Memorandum

To:	Mr. Greg Wands Chair, Ashland Conservation Commission	Project Number:	24142
From:	Will Park, PE	Date:	12/23/2025
Project Name:	61 Waverly Street – Notice of Intent		
RE:	Response to Comments - Hearing 1/5		
Distribution:	Israel Lopez - The Gutierrez Company, Mark Arnold - Goddard Consulting, Luke Norton & Corinne Disenhof - Sanborn Head & Associates

THE RESIDENCES AT ASHLAND
61 WAVERLY STREET
ASHLAND, MA

EXISTING CONDITIONS PLAN

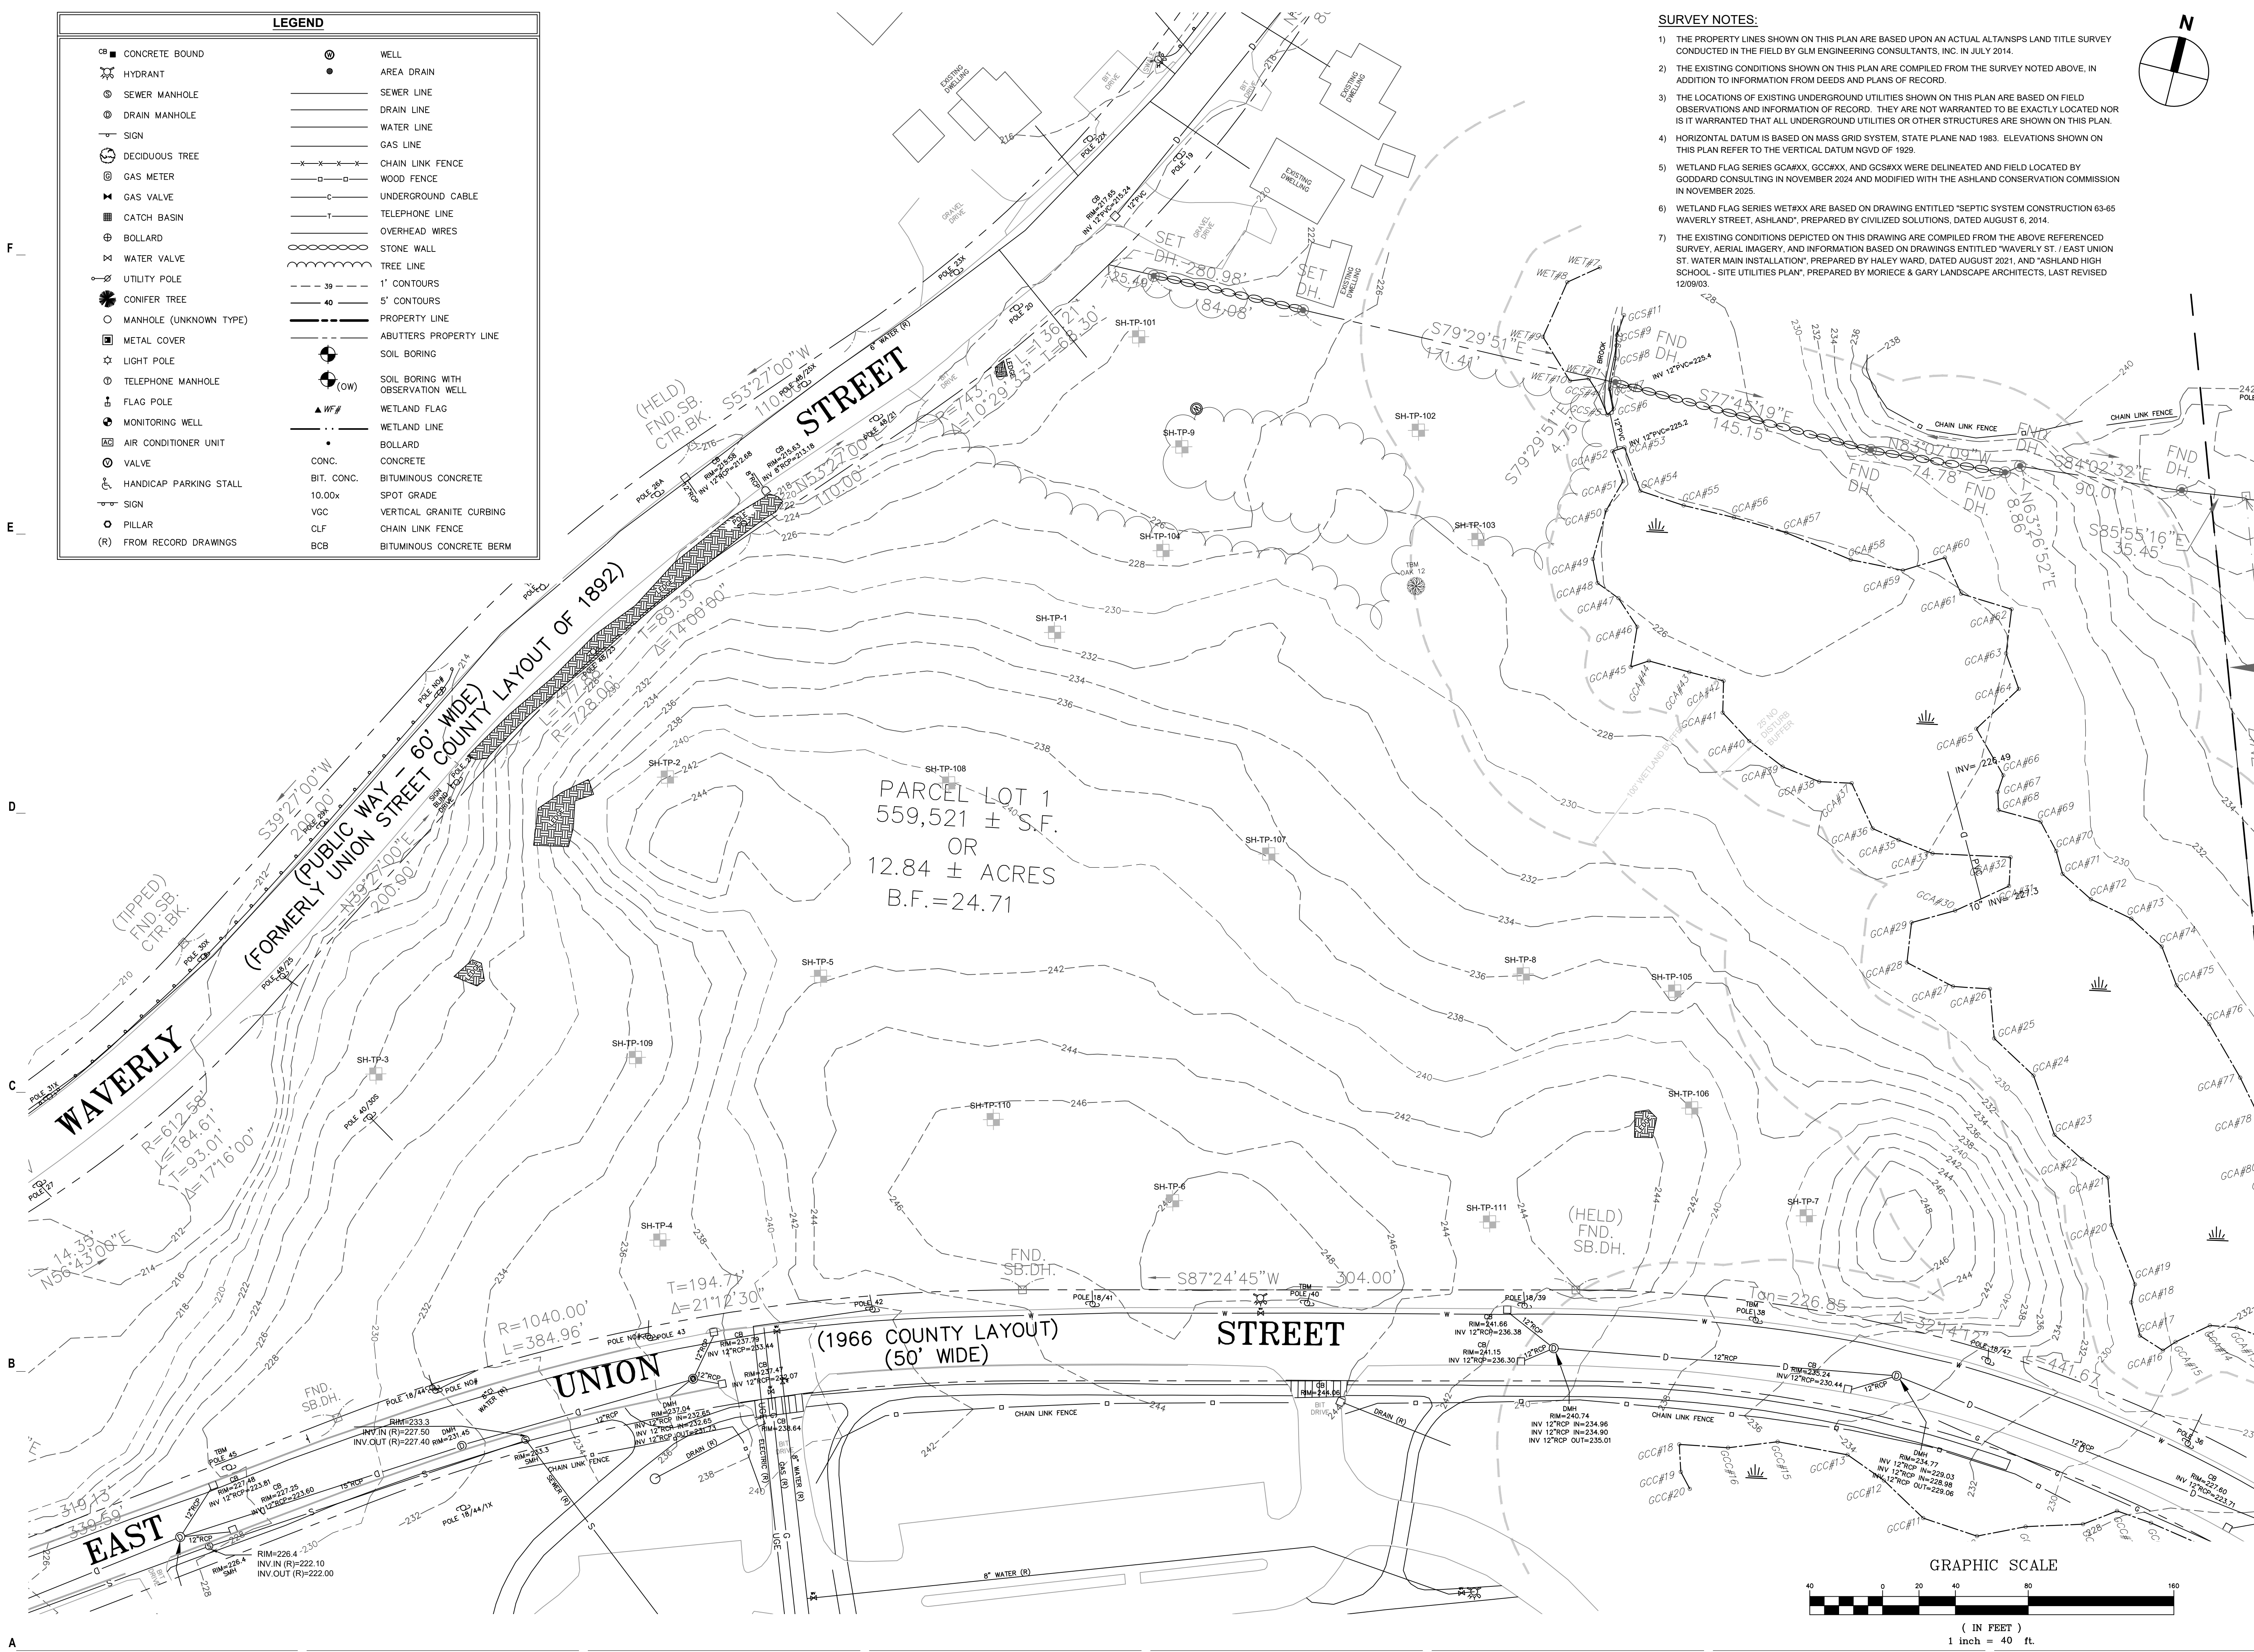
- Goddard reviewed a 2014 wetland delineation for the 63-65 Waverly Street property as it pertains to the bank of the ditch where it abuts 61 Waverly Street. That delineation differs slightly from the delineation Goddard conducted on November 20, 2024. However, Goddard will respect that delineation and will tie into it where the line crosses onto the subject site. As such, Goddard has adjusted its November 2024 wetland line delineation on the project-side. Specifically, wetland flags WET #10 and 11 from the 2014 delineation will be retained. WET #11 will connect to GCA#4. This will require minor grading adjustments to the site to respect the 25-foot No Disturbance Buffer Zone. **Exhibit 2** is the updated

Existing Conditions Plan C-101 reflecting this change

- Wetland flag GCA#34 was eliminated and wetland flag GCA#33 was connected to GCA#35, thereby shifting the wetland line further upland. This area was questionable in whether it was upland or wetland but it was considered best to just eliminate GCA#33 to protect the area and delineate it as part of the wetland. Attached as **Exhibit 2** is the updated Existing Conditions Plan C-101 reflecting this change
- Attached as **Exhibit 2** is the Existing Conditions Plan C-101 with the updated delineation.
